Service Bulletin

Bulletin No.: 18-NA-069

Subject: Poor Engine Performance in Extremely Cold Weather Conditions for LFV Engines, Charge Air Cooler Icing - Malfunction Indicator Lamp (MIL) Illuminated - DTC P0299, P0234, P2227 and/or P00C7 Set

Brand:	Model:	Model Year:		VIN:		Engine:	Transmission:
		from	to	from	to		
Chevrolet	Malibu	2016	2025	—	—	1.5L (LFV)	—

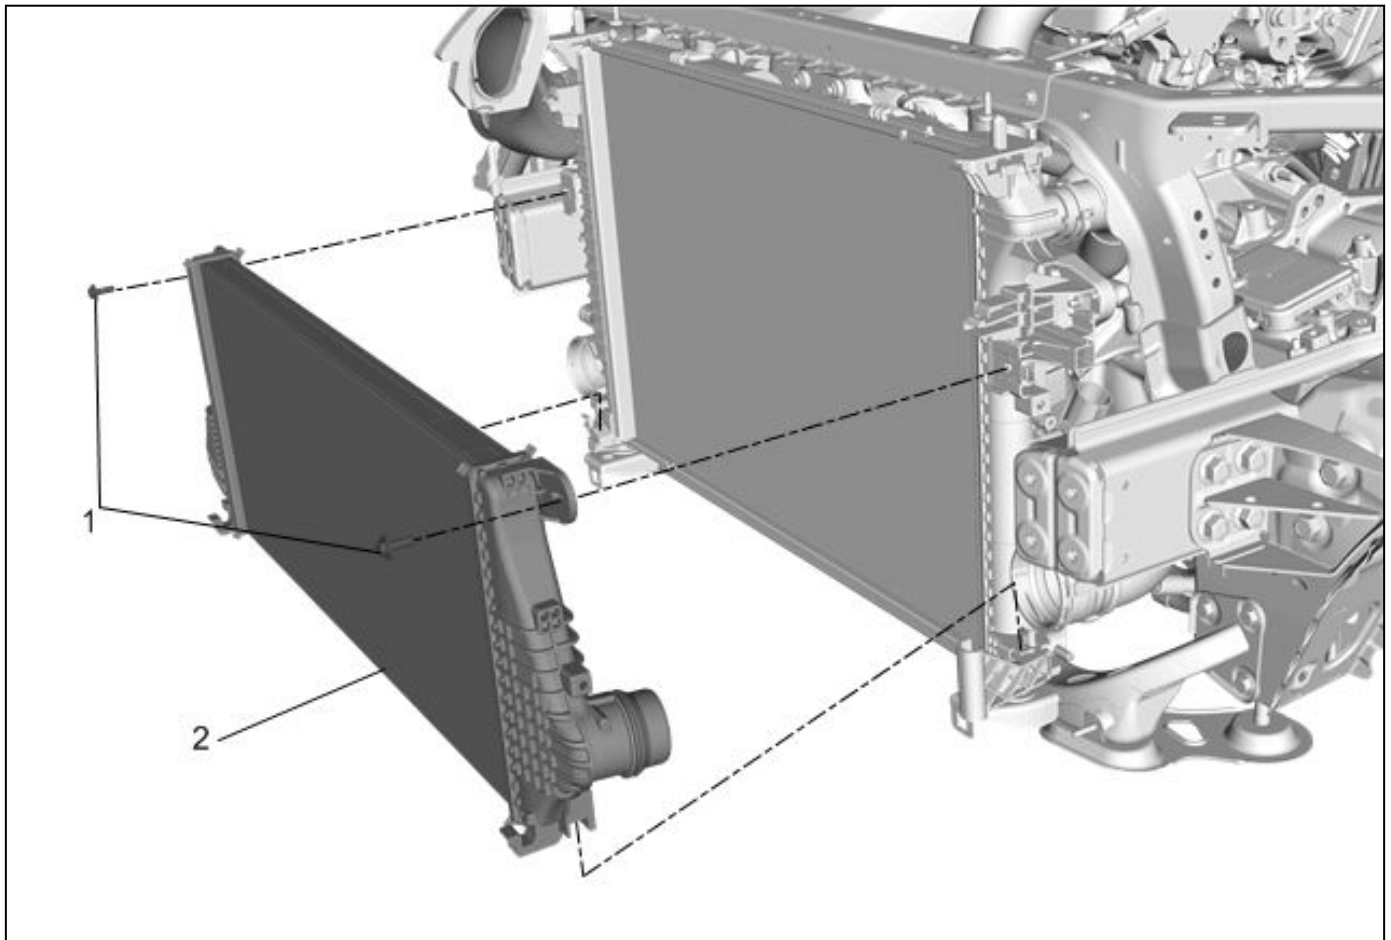
New winter grille covers have been released to prevent this issue from occurring in extreme cold weather (-18°C or less/0°F or less). The winter grille cover needs to be added to avoid the customer from returning with concerns related to charge air cooler icing. Please refer to the Parts Information section for the appropriate part number.

The winter grille cover can be installed by the technician during the repair procedure as listed in this bulletin. After the repair is complete, dealer service personnel must educate the customer on the installation and removal procedure of the winter grille cover. Installation instructions are included with the winter grille cover.

Important: *The winter grille cover should be installed in the extreme cold weather and removed when the winter season changes. Additional covers and repeat installation are customer pay.*

Note: *Clean the surface before installing the winter grille cover.*

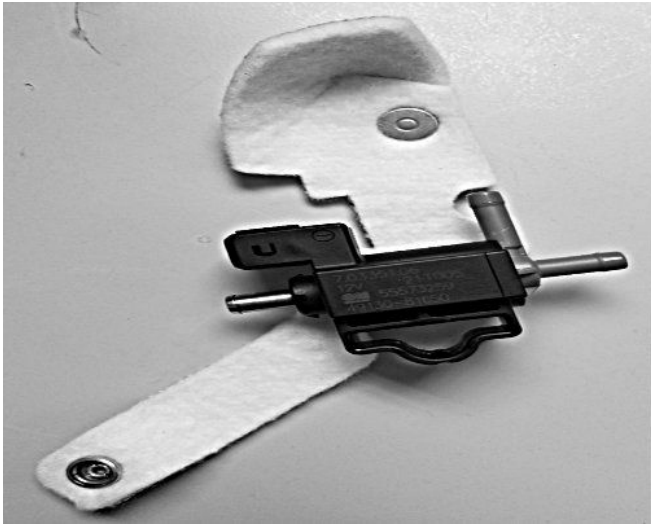
Note: Check port #2 to assure the spring gets lifted off the seat. This will be determined by the compressed air not dead heading when applied to port #2. When applying air to this port, a small amount of air should be observed at port #3 and even less air will be noticed at port #1. If this does not happen, the TCV plunger may have

hardened deposits from hot operating conditions which will impede TCV plunger movement, and the TCV should be replaced.

4. Using clean shop air regulated to 80-100 PSI, blow through all three ports (1, 2 & 3) for 5 seconds each.
⇒ Repeat step 4 twice.

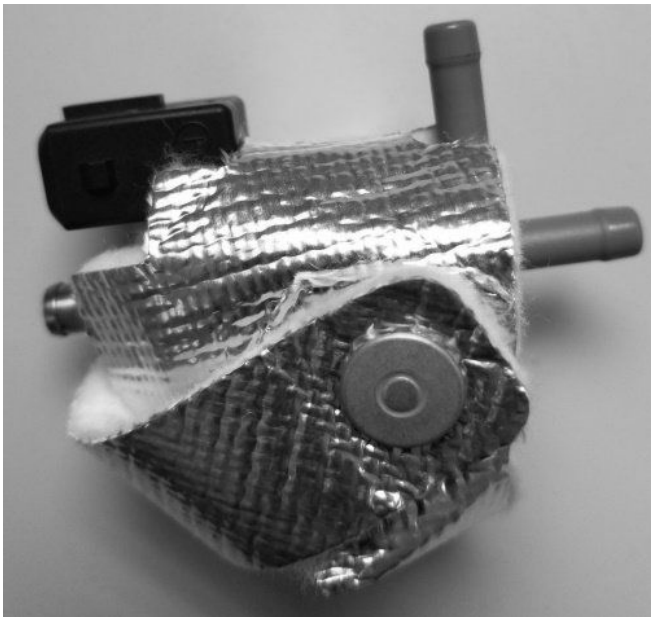
5. Prior to reinstalling the TCV, pre-position the thermal wrap. This will aid in installation of the wrap once the TCV is reinstalled.

Note: The end result of the wrap will surround the TCV as shown in the graphic above.

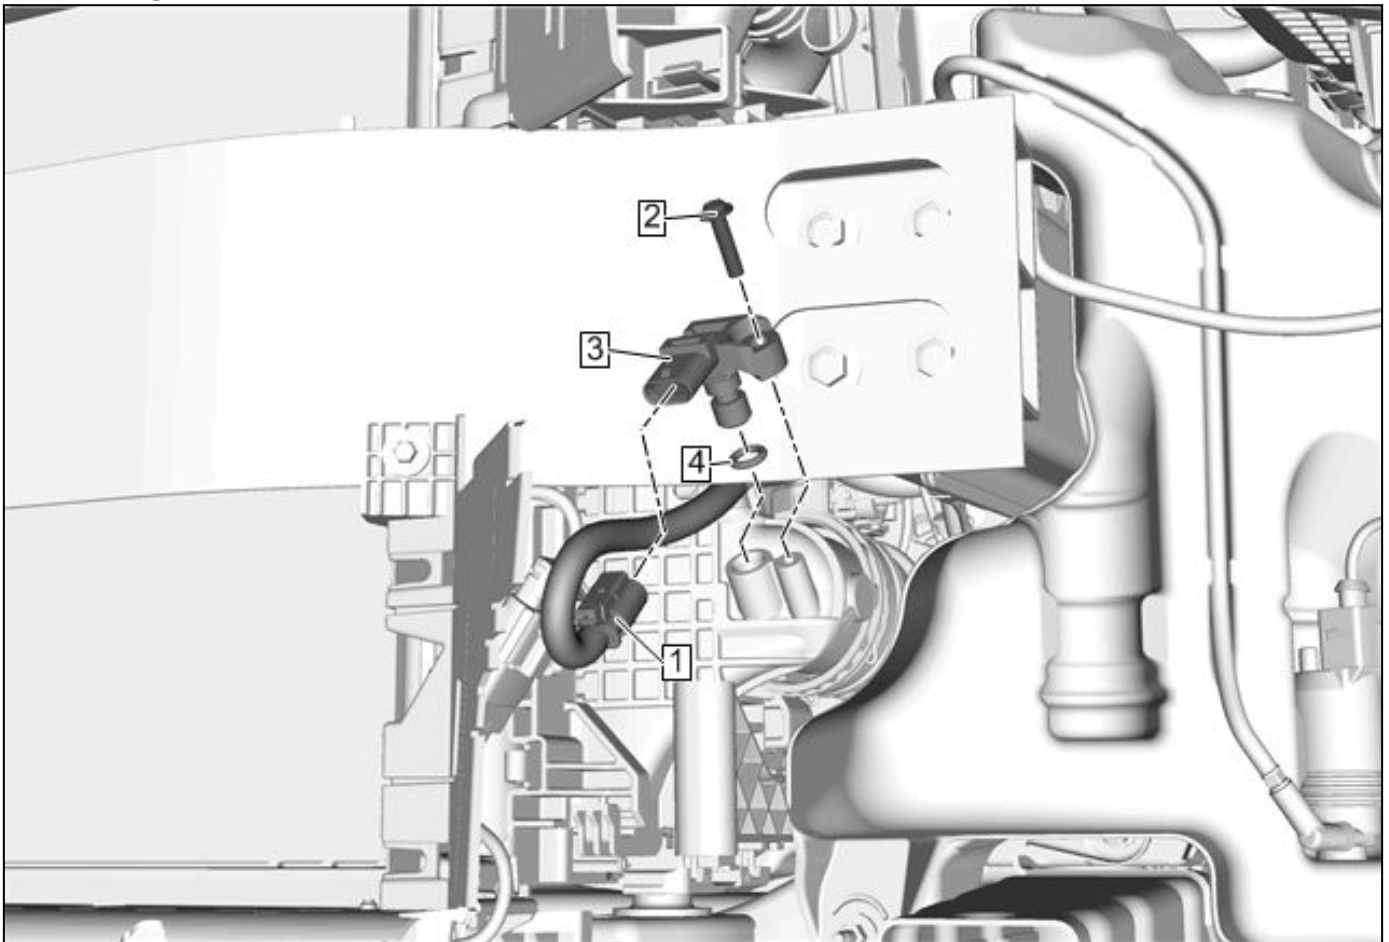
6. Install the TCV. Refer to *Turbocharger Wastegate Regulator Solenoid Valve Replacement* in SI.

7. Once the mounting bolt and hoses are properly installed, pull the lower portion of the wrap upward and snap it into position.
8. Clear all DTCs using GDS and evaluate.

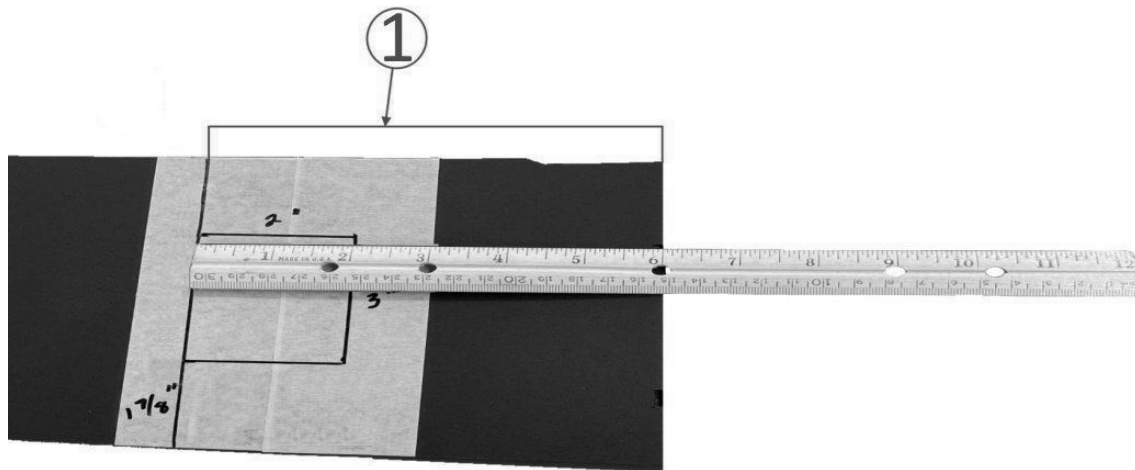
1. If installed, remove the license plate bracket.
2. Remove the mounting clips (1) from the cover.
3. Locate the center (2) on the grille cover.
4. Cut the cover in half.

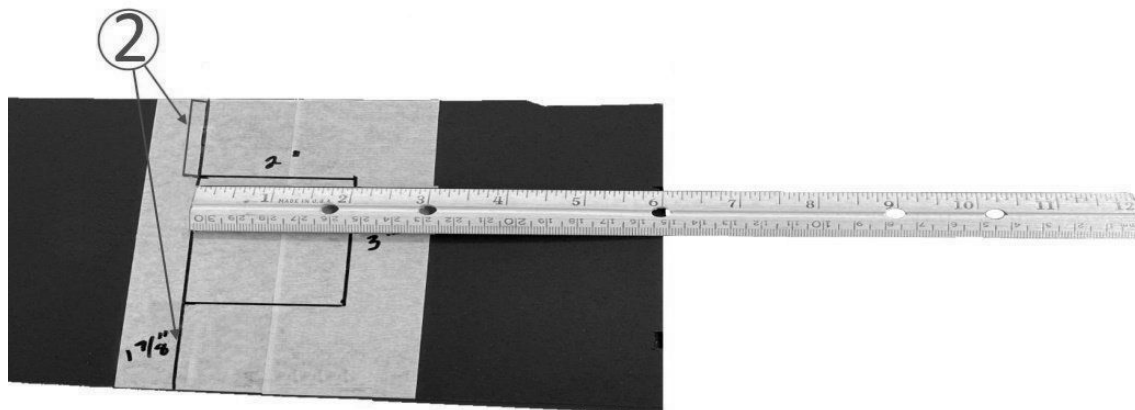
5. Apply painters tape across the entire height of the grille cover, approximately 17.8 cm (7 in) from the center of the cut end of the cover.
6. Measure 17.8 cm (6 in) across the top (1) of the cover and leave a mark.
7. Measure approximately 17.8 cm (6 in) across the center as indicated in the graphic above of the cover and leave a mark.
8. Draw a vertical line between the two marks.

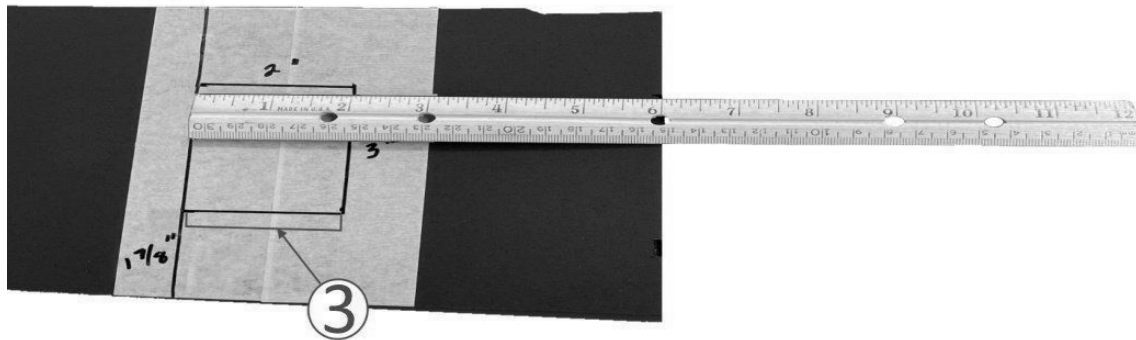
9. Measure **approximately 47.6 mm (1 7/8ths of an inch)** (2) from the top and from the bottom and leave a mark.

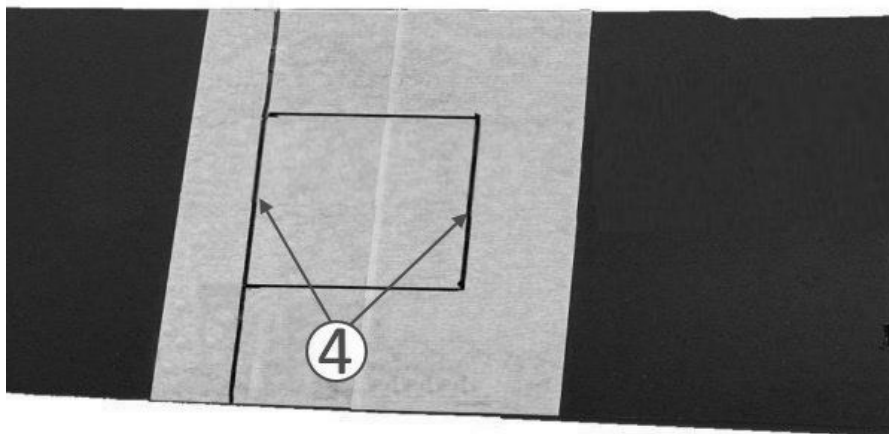
10. From the top and bottom marks, measure towards the center of the cover 50.8 mm (2 in) (3).

Note: The box created (4) should measure 50.8 mm x 76.2 mm (2 x 3 in).
